SIB 52 19 23

SECOND ROW 60/40 SEAT RAIL FLEX CABLE REPLACEMENT

2025-03-27

This Service Information Bulletin (Revision 2) replaces SI B52 19 23 **dated December 2024**.

What's New:

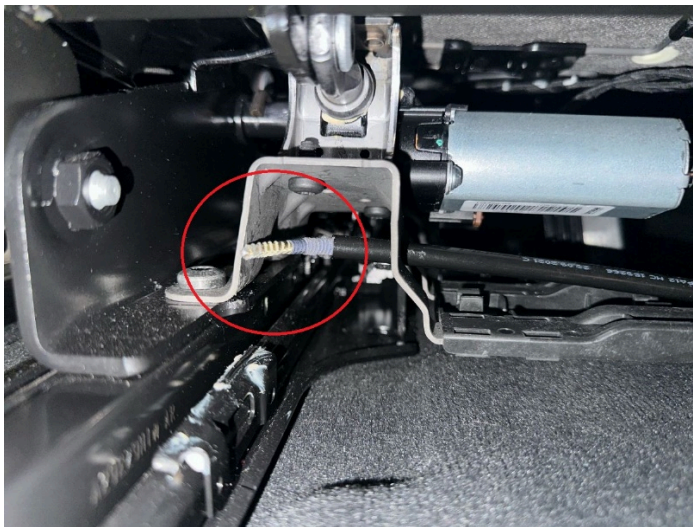
- Locking clip information added. The locking clip will be available in July 2025. Until then reuse the existing locking clip.
- Correction revised
- Procedure revised
- Parts Information revised
- Attachment modified

SITUATION 1

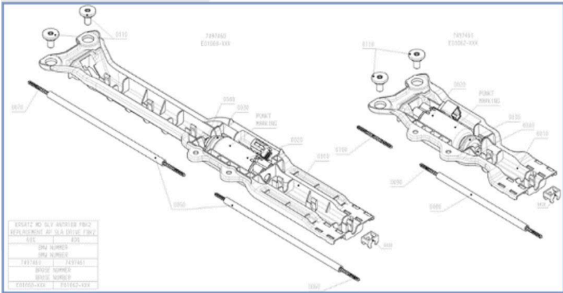
The plastic SLV Motor Carrier tray is broken.

The plastic SLV Motor Carrier tray is available with flex shaft kits.

**SITUATION 2**

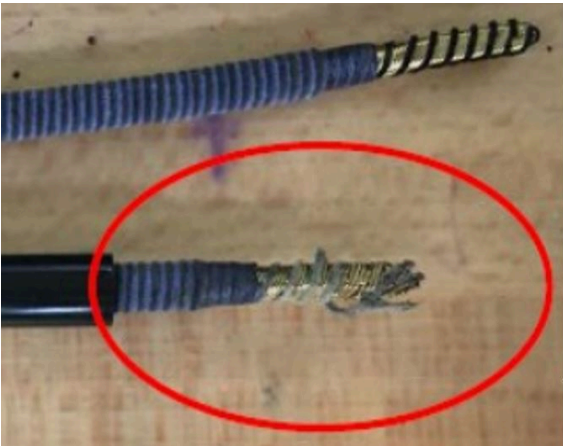
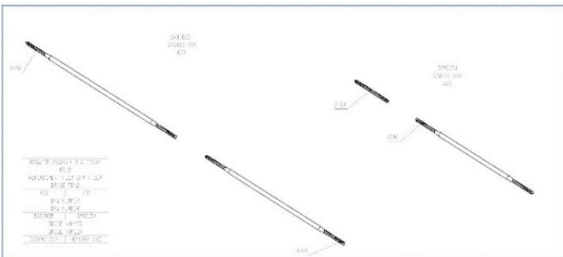
The flex cable is damaged.

If the flex cable end has been damaged, do not reuse it.

Replace only the damaged flex cable assembly instead of entire seat rail assembly. Install a new locking clip as per situation 3.

NOTE: The locking clip will be available in July 2025. **Until then reuse the existing locking clip.**

**SITUATION 3**

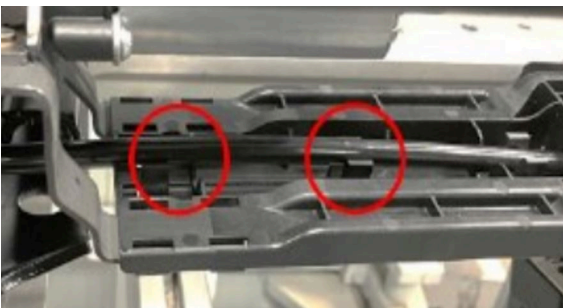
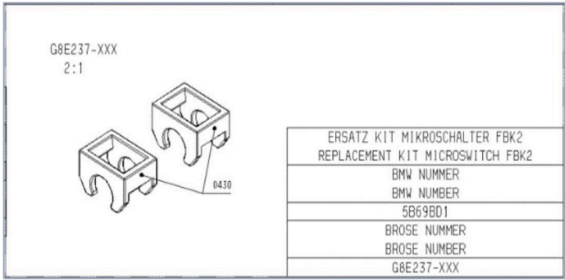
The Flex Cable has popped loose from the U-shaped flex shaft hooks. If the flex cable end is not damaged, check the U-shaped hooks on the plastic carrier.

- If the U-shaped hooks are damaged, replace SLV Motor Carrier tray (see situation 1)
- If the U-shaped hooks are not damaged, reinstall flex cable into U-shaped hooks and replace locking clip

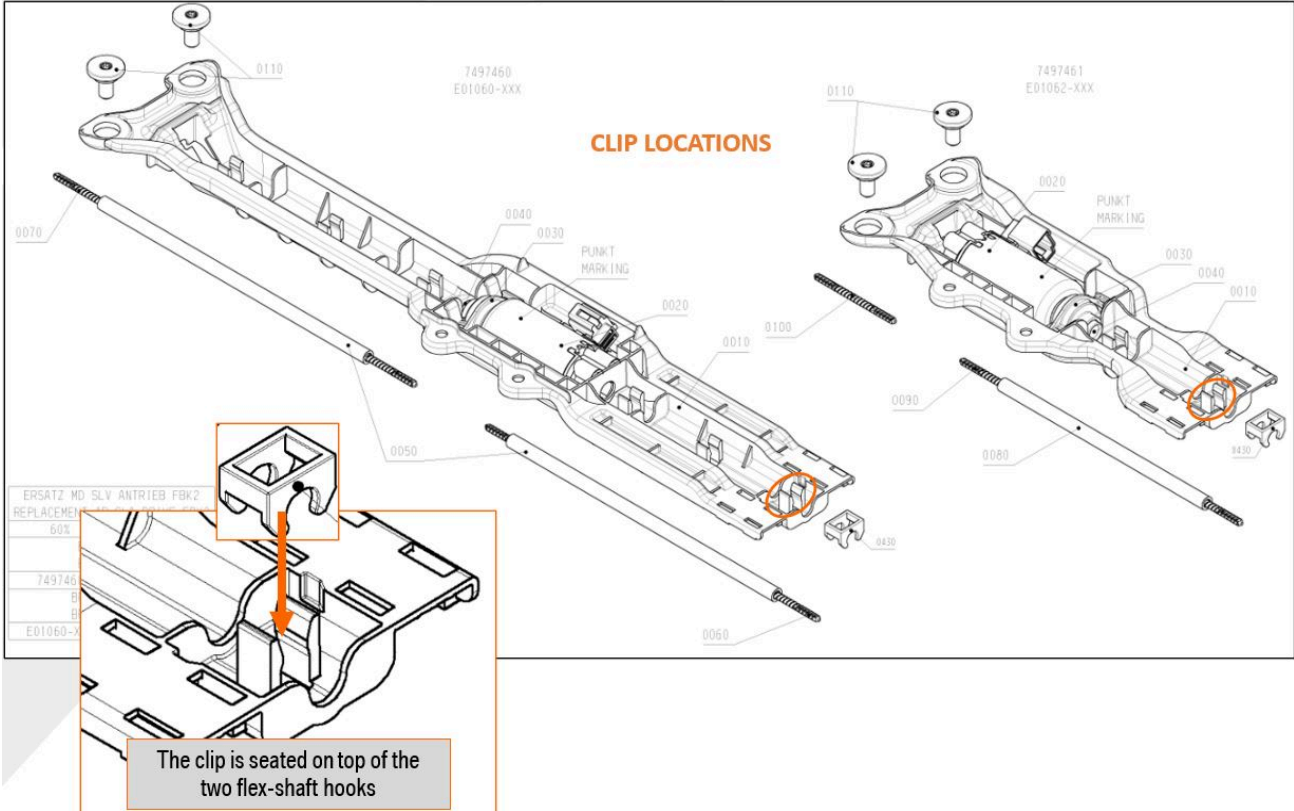
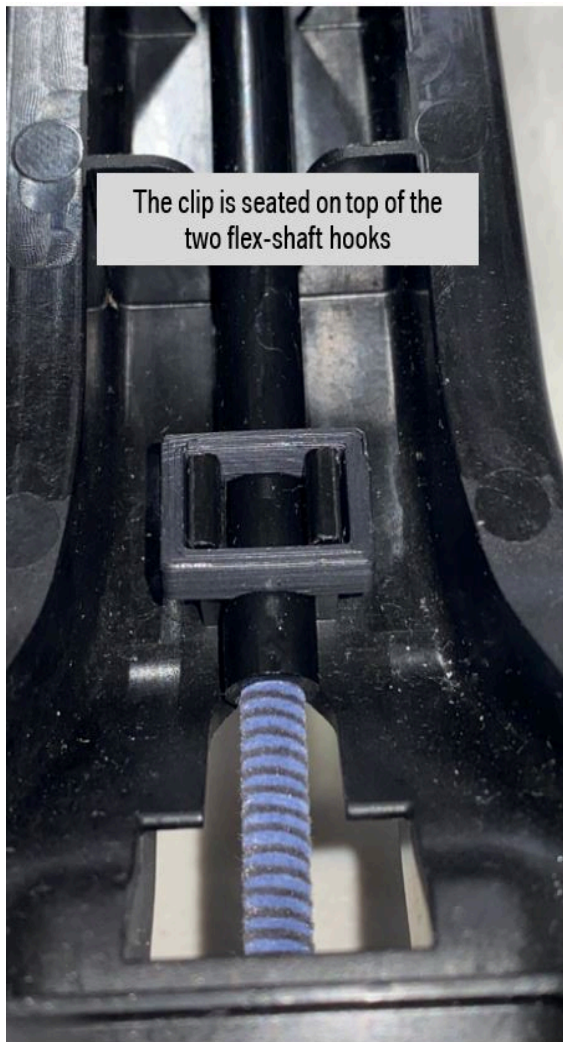
The locking clip is shown in ETK to be used in conjunction with flex cable repairs.

NOTE: The locking clip will be available in July 2025. Until then reuse the existing locking clip.

NOTE: If this locking clip has come loose due to the cable popping free, it should be replaced.
